MOLALLA PLANNING COMMISSION MEETING

Subject:	File Number DRW01-2019, Tax Lots 52E08C, 400, 500, 600, 700, 800, 801 & 900
Recommendation:	N/A
Date of Meeting to be Presented:	May 15, 2019
Fiscal Impact:	N/A
Submitted By:	City Planner, Alice Cannon
Approved By:	City Manager, Dan Huff

Background:
Public Hearing; DRW01-2019 Ivanoff Investment Group. Subdivision and Site Design Review for a new commercial subdivision.

Figure 17-3.3-2 Vision Clearance

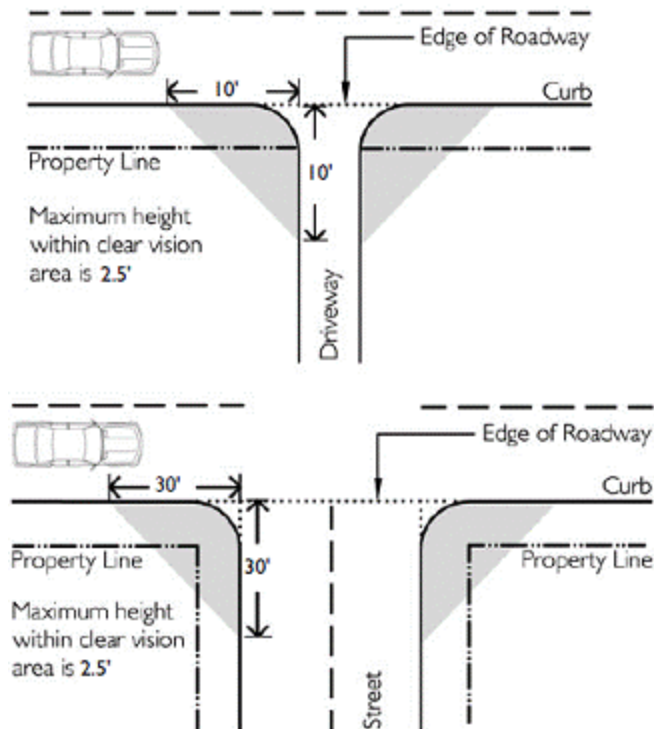
FINDING: Staff recommends, as a condition of any final approval, that the Applicant/property owner be required to continuously maintain all required Vision Clearance areas as shown in Figure 17-3.3-2.

- d. Site and building design plans showing consistency with required vision clearance areas as shown in Figure 17-3.3-2.
- e. Walkways and primary building entrances shall be designed consistent with building design standards of Section 17-3.2 and, where required, ADA requirements.

DATE: 01/28/19
 SCALE: AS SHOWN
 DRAWN BY: GS
 DESIGNED BY: GS
 CHECKED BY: GS
 FILE: CCCD01P22.dwg
 SHEET NUMBER
P2.2

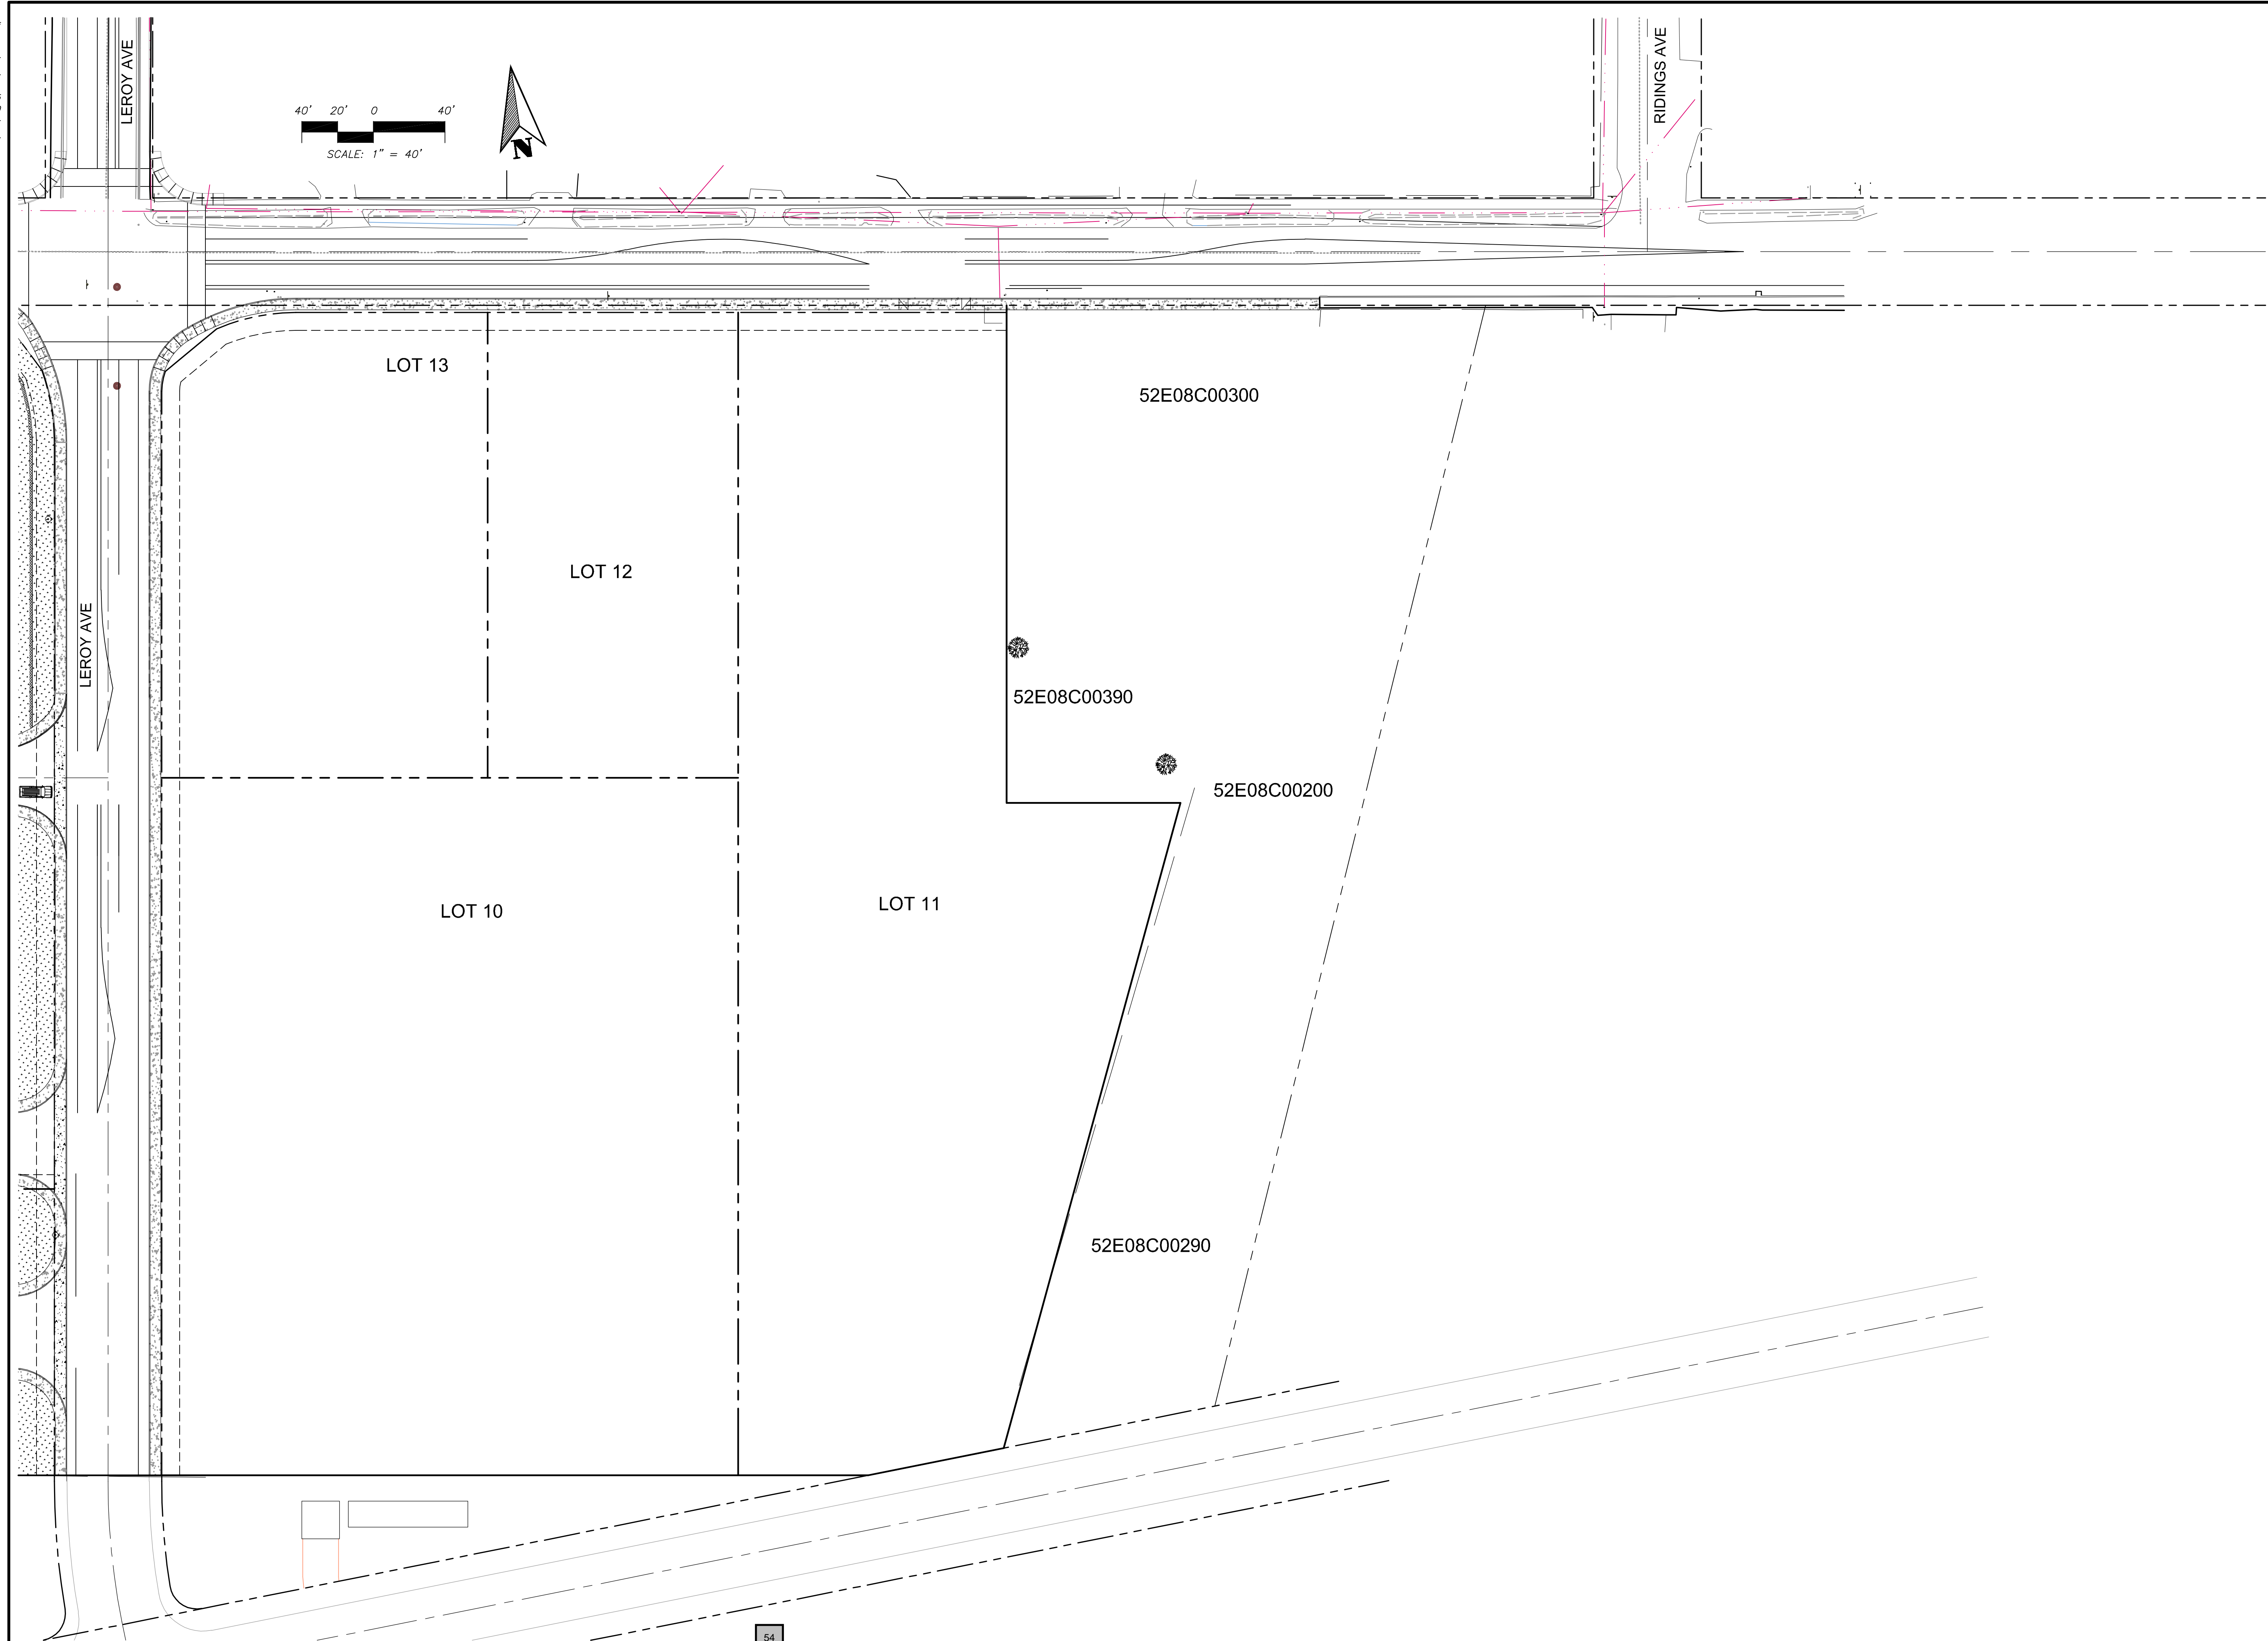
Access to public streets shall be limited to the accesses shown on Sheet P2.2 of the plans and attached to these conditions. Access spacing shall conform to the Transportation Systems Plan. The proposed width of accesses shall meet the Molalla Standard Specifications for Public Works Construction.

- vii. Submit a revised site plan designating east-bound bus stop location in accordance with the City's Transportation System Plan project T7.
- viii. Access to public streets shall be limited to the accesses shown on Sheet P2.2 of the plans submitted with this development review application. Access spacing shall conform to the Transportation Systems Plan. The proposed width of accesses shall meet the Molalla Standard Specifications for Public Works Construction.
